**AMENDMENTS TO THE DRAWINGS**

ANNOTATED SHEET  
APPLICATION SERIAL NO. 10/730,281

FIG. 5

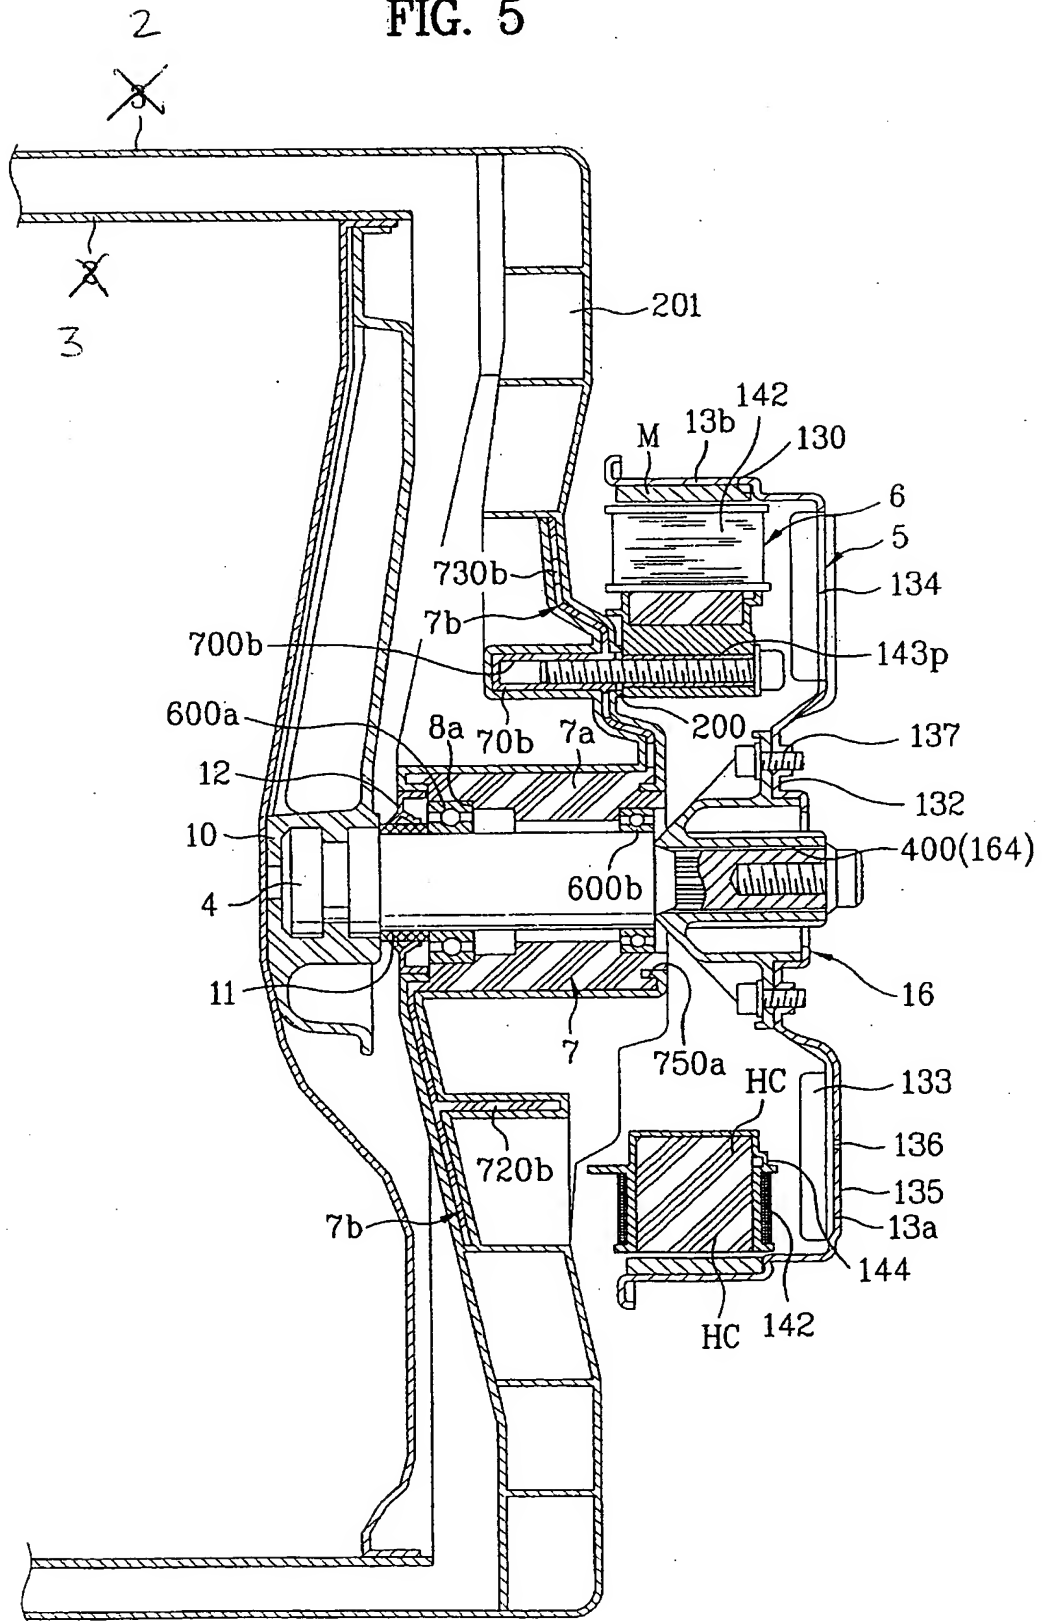
In Figures 5 and 14, the reference labels “3” have been amended to --2--, while the reference labels “2” have been amended to --3--.
